ADDENDUM No. 1

Date: May 23, 2025 **Project No:** M24017

Project Name: Request for Tender: Town of Shelburne, Fiddle Park Upgrades

Fiddle Park Tender - Landscape Addendum

SPORTS & PLAYGROUND

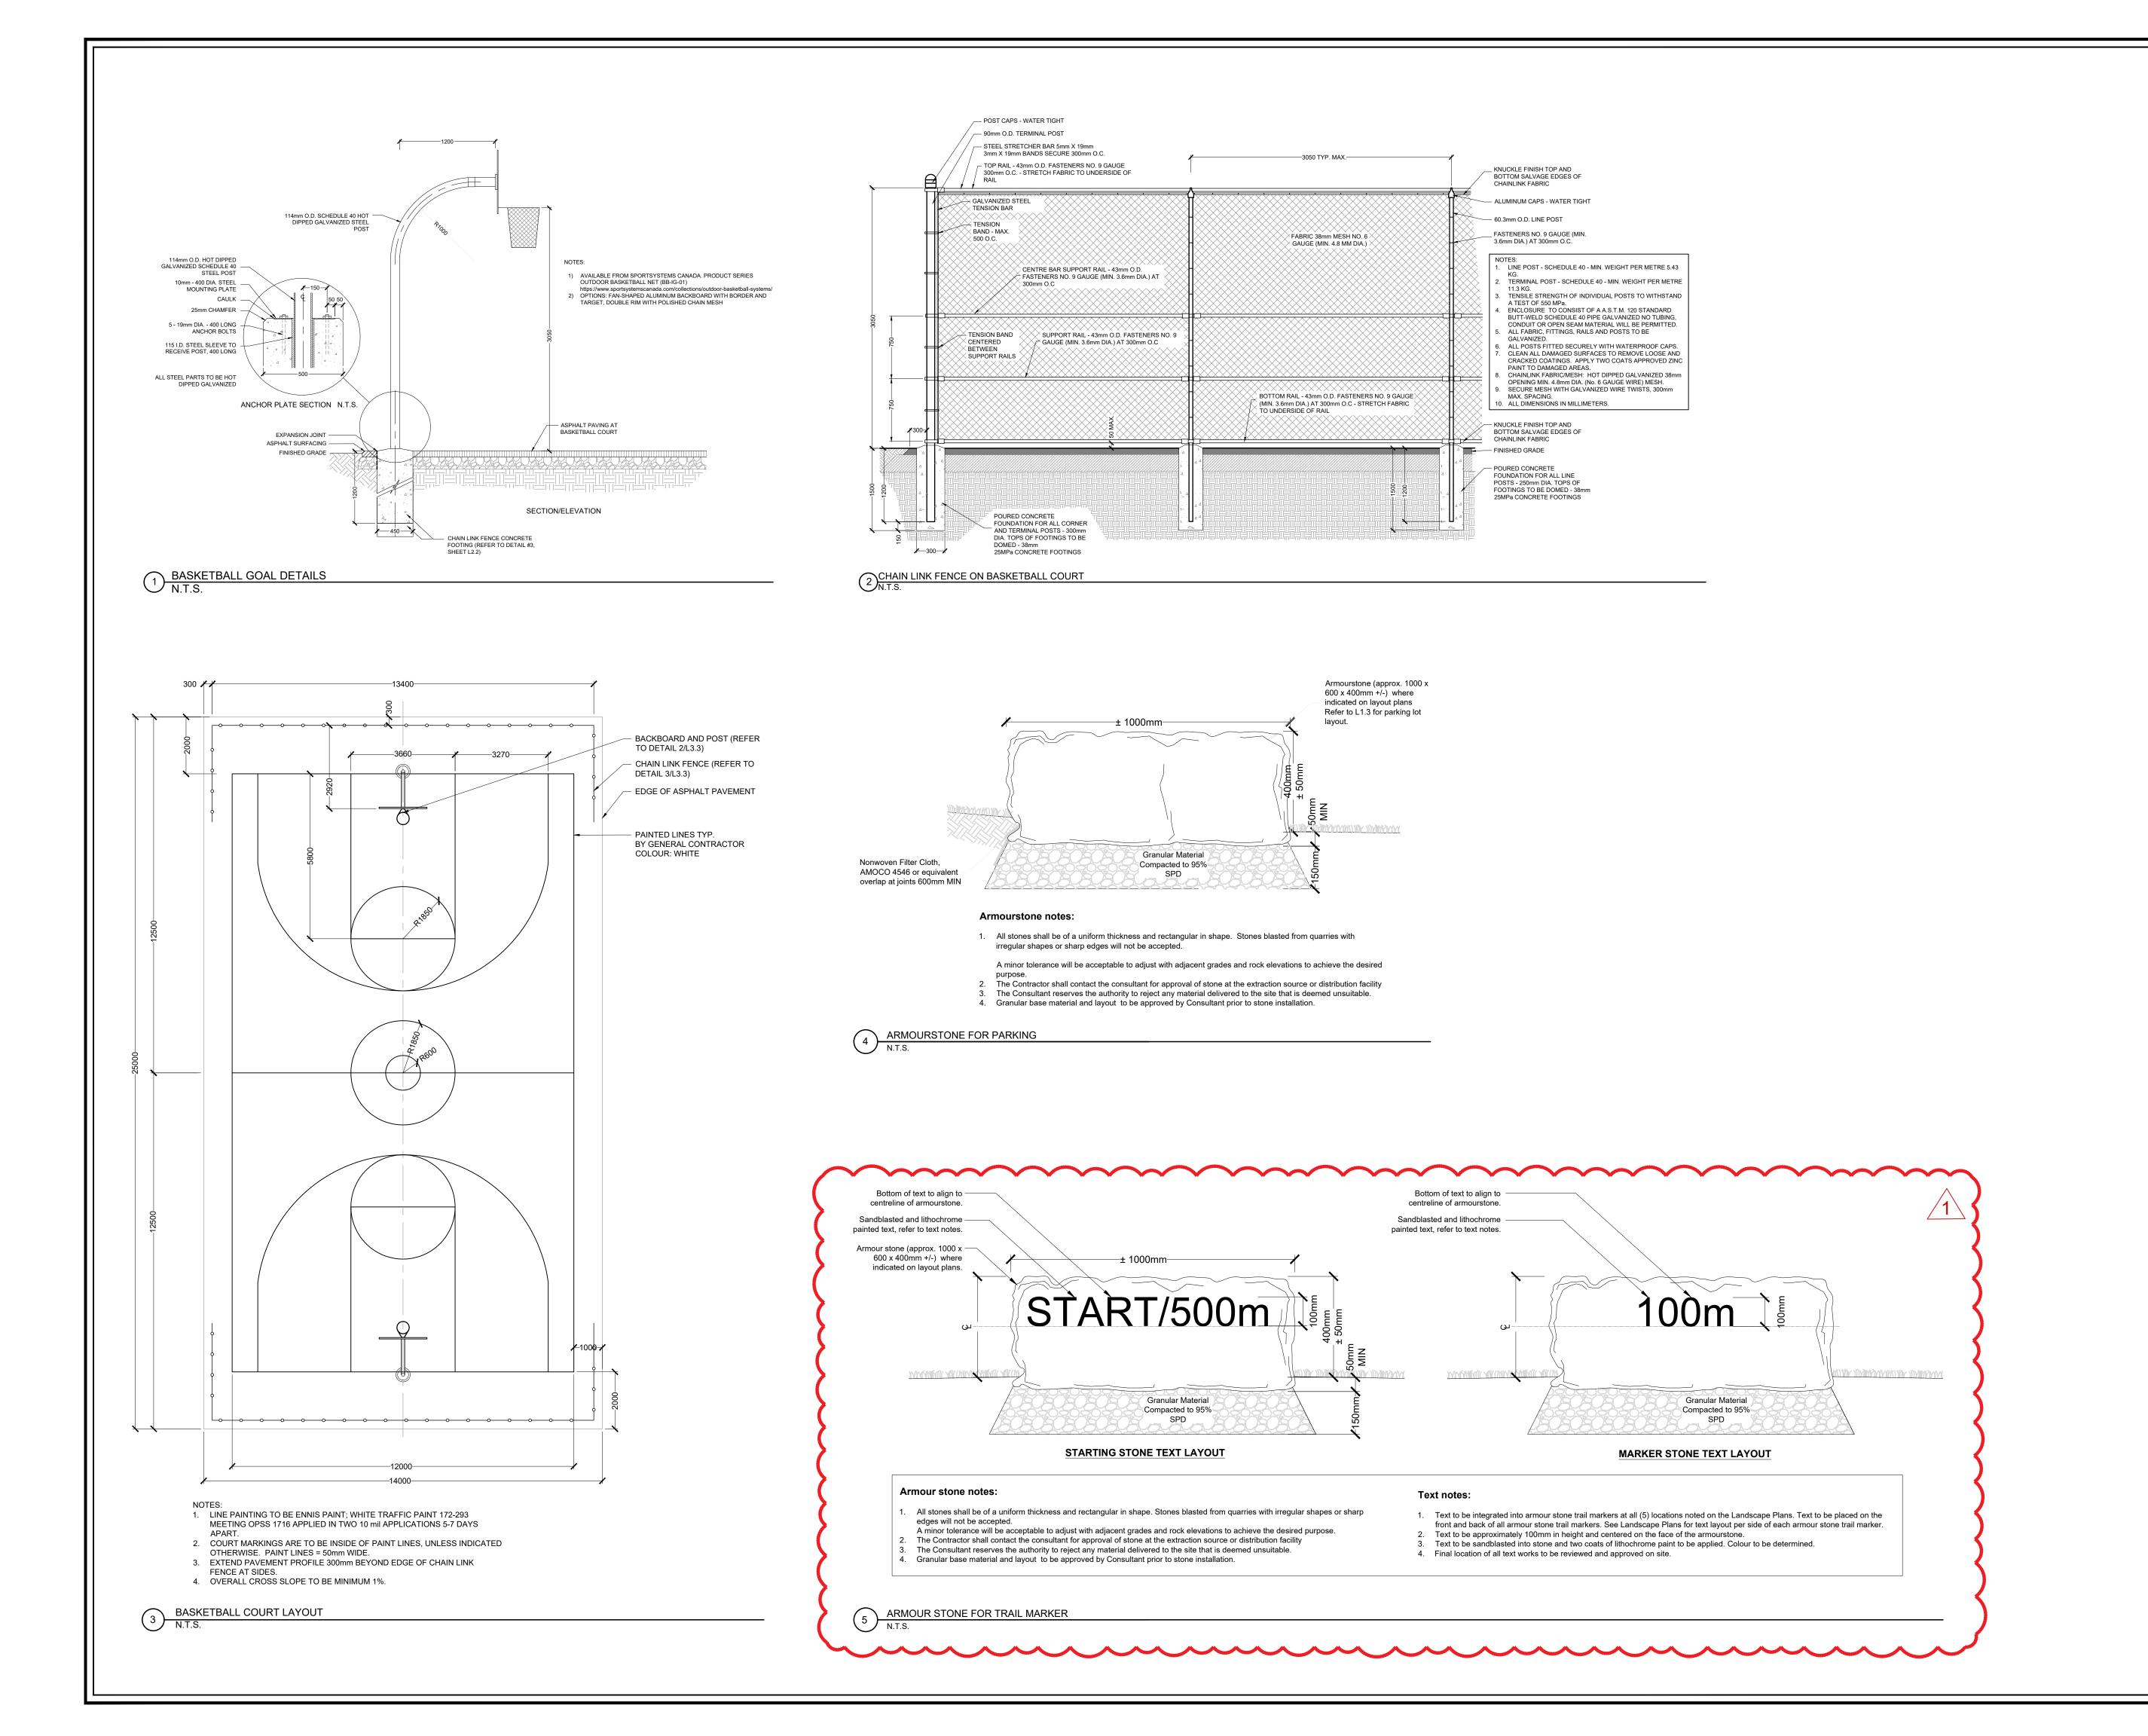
- Question 1: I see the bid document calls for Builder's Risk insurance on page 7, could you please
 - confirm it doesn't apply as there is no building included?
- Response 1: Builder's Risk Insurance is not required.
- Question 2: Is the armour stone for the tiered seating the same as the armour stone for the parking
 - lot?
- Response 2: The armour stone products for the tiered seating and the parking lot do not have to be

the same product. We will also be using armour stone for the trail markers – Refer to

- Landscape ADD001 for new Detail 5/L3.3.
- Question 3: Can the watermain on the middle road be capped and grouted instead of removing?
- Response 3: The watermain section on the middle road can be isolated, capped, and grouted. If this

S5.1

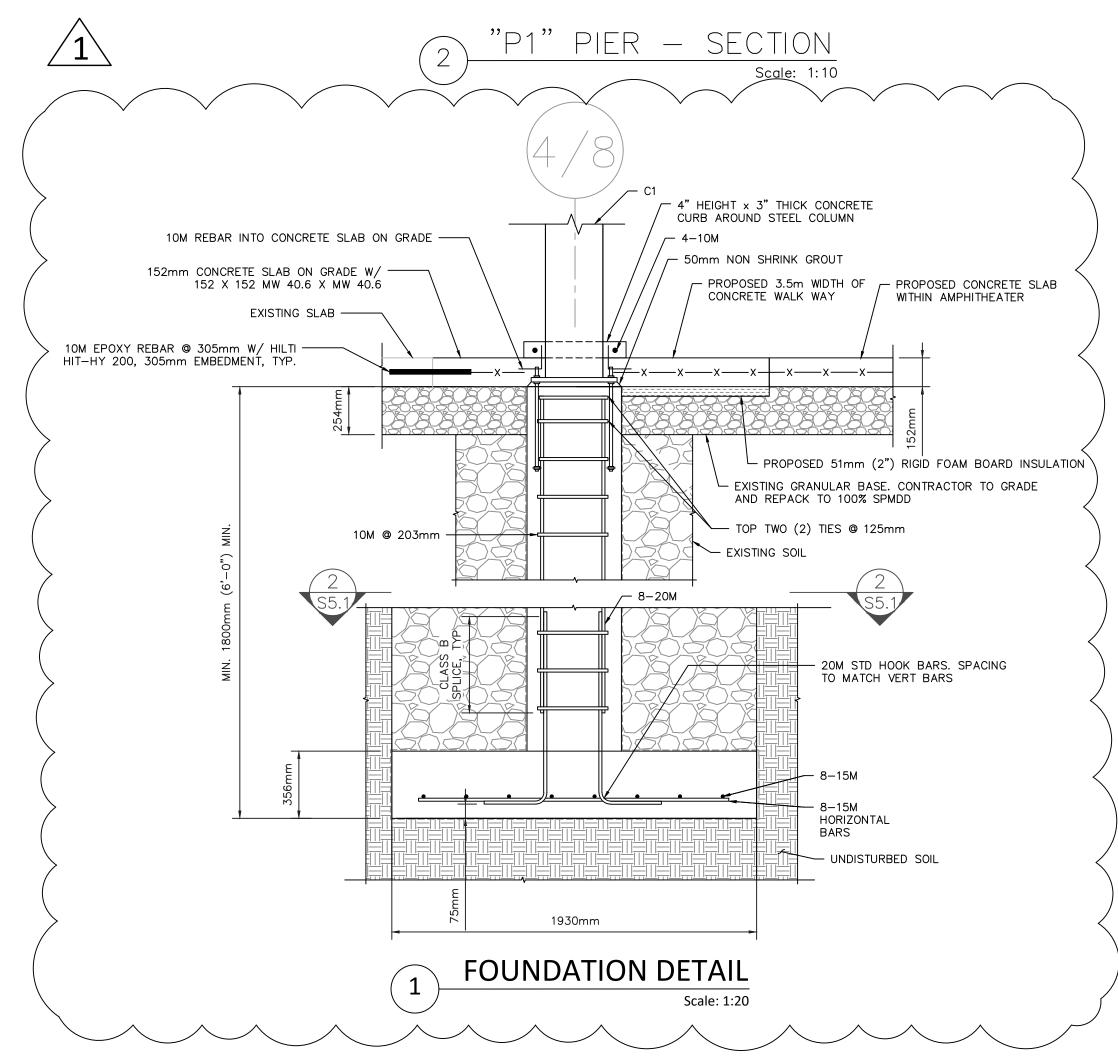
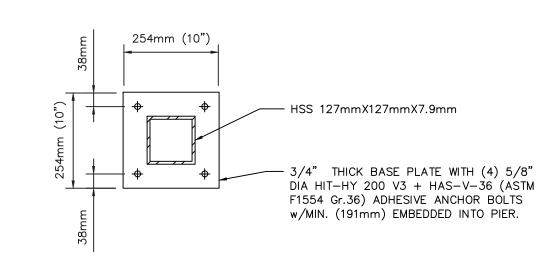
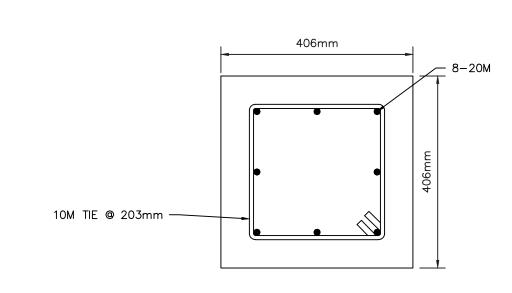
- Question 16: There is a note discussing doweling of this 3 m slab with the existing pavilion concrete. If this is required please provide the spacing. Is this dowling to be installed between the proposed concrete slab for the amphitheater floor and the proposed 3 m walkway as well as between the 3 m walkway and the existing concrete slab of the pavilion?

- Question 17: Drawing S5.1, Detail 1: Thicken slab around base plate, please provide detail for this work.
- Response 17: The "thicken slab around base plate" note has been removed. Detail 1 has been revised on Drawing S5.1 attached.
- Question 18: Item A5, Environmental Mitigation Measures, we do not see any information required to price this work?
- Response 18: As stated under Item A5 in the Special Provisions, Environmental Mitigation Measures shall include:

- Response 16: Dowling shall be between the existing pavilion slab and the proposed amphitheater slab.

Dowling to be spaced at 305 mm as per the revised Detail 5 on Drawing S5.1. The walkway

can be a continuous pour with the amphitheater floor (with 3.5 m width of 2" rigid insulation under the walkway portion).
